From: Anna Williams
Sent: 27/09/2023 7:27:47 AM
To: Council Northernbeaches Mailbox; Claire Ryan
Cc: garry ummer
Subject: TRIMMED: Submission objecting to DA2023/1245 at 212 Hudson Parade Clareville
Attachments: Submission 212 Hudson Parade Clareville.pdf;

RE: DA2023/1245 Demolition and construction of a new dwelling including swimming pool

Figure 1: Section showing 3 storey development throughout the design, clear absence of stepping in the structure, and excavation in excess of 5m.

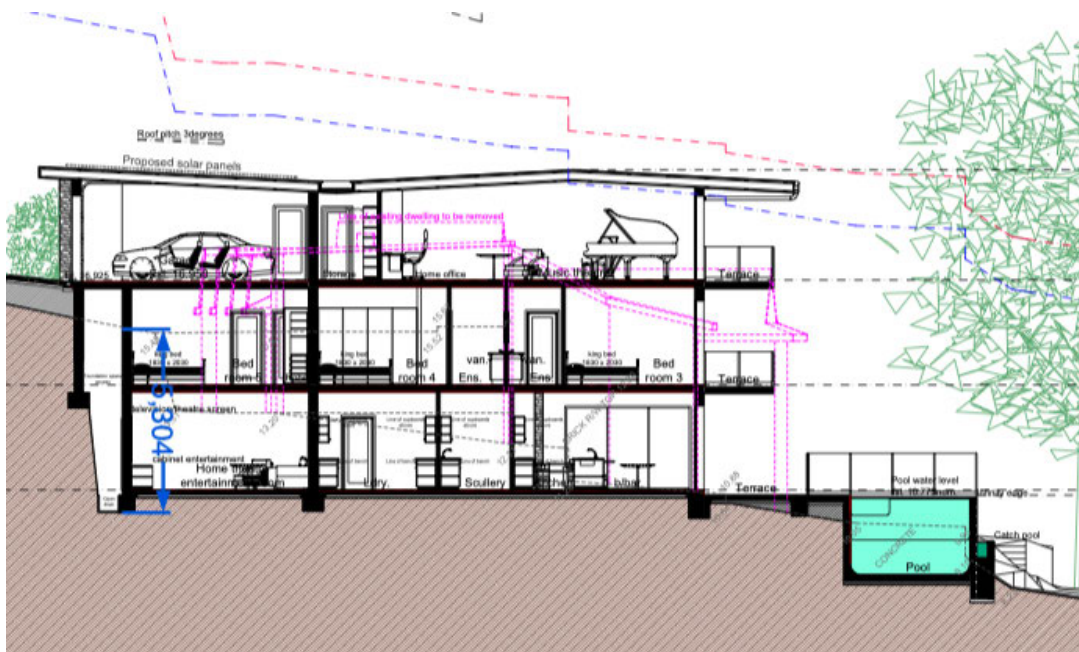
The design offers no stepping of its form at all, and furthermore proposes significant levels of excavation to create a basement level, being in excess of 5m cut. We note that this massive excavation is proposed less than 2m from the shared boundary with No. 210 Hudson Parade. The clear insistency with this provision is obvious from the section drawing at Plan 11, reproduced below:

As evidence in previous Figure 1, the proposed design does not seek to work with the slope of the land and seeks to excavate and fill areas to create desired levels. There is no stepping of the structure, and the design cannot meet the above test.

Figure 3: The above annotated roof plan showing survey levels has been used to calculate the maximum slope under the footprint of 28%. This is best case as the majority of the gradients are <25%. **Source:** RJP Design, Annotation by Blackwattle Planning

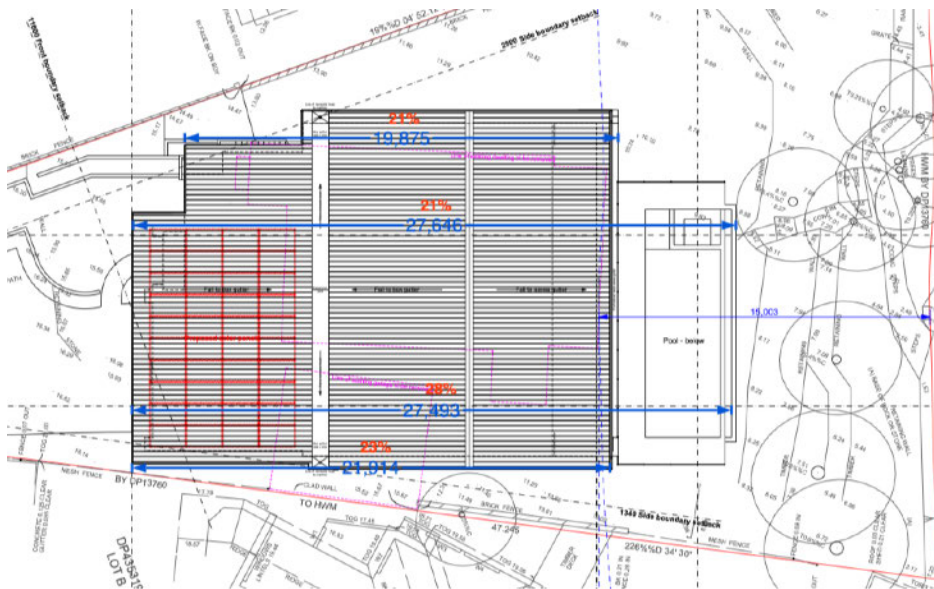
To utilise Clause 4.3(2D), an application must demonstrate that the slope of the land under the building footprint is greater than 30%. We have made multiple calculations based upon the survey information provided by the applicant and cannot see how the proposed footprint meets this criteria. The calculations are demonstrated below:

The design fails this test of Clause 4.3(2D) and cannot rely on this provision to justify its height above 8.5m.

Figure 4: Breach of Building Envelope shown as the built form above the red dotted line. **Source:** RJP Design, Annotation by Blackwattle Planning

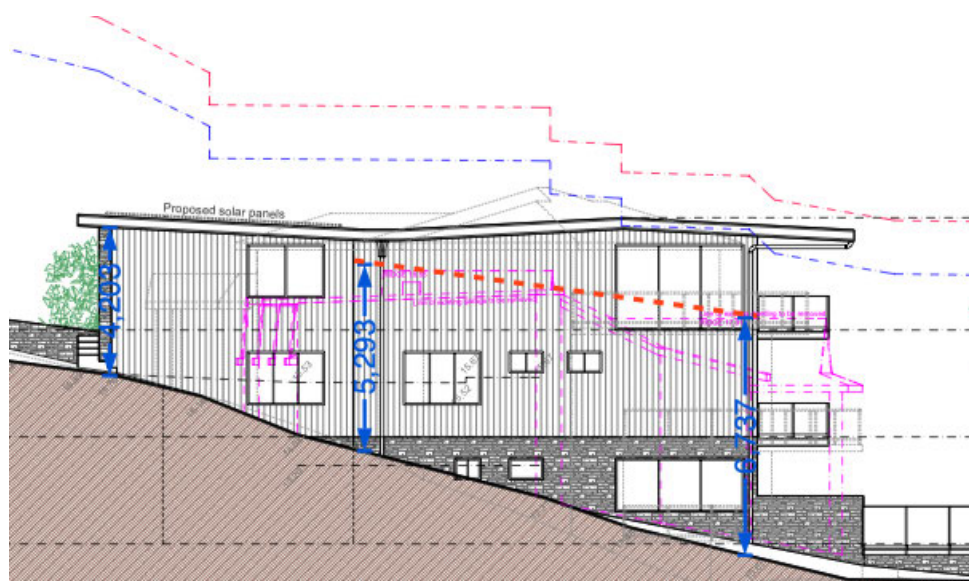
A significant proportion of the upper level of the proposed dwelling falls outside this building envelope. The point the envelope intersects the north western wall is shown below by the red dotted line:

Together with the breach of the height limit, the Building Envelope breach will result in view loss, excessive bulk and scale, and significant visual impact as viewed from the waterway.
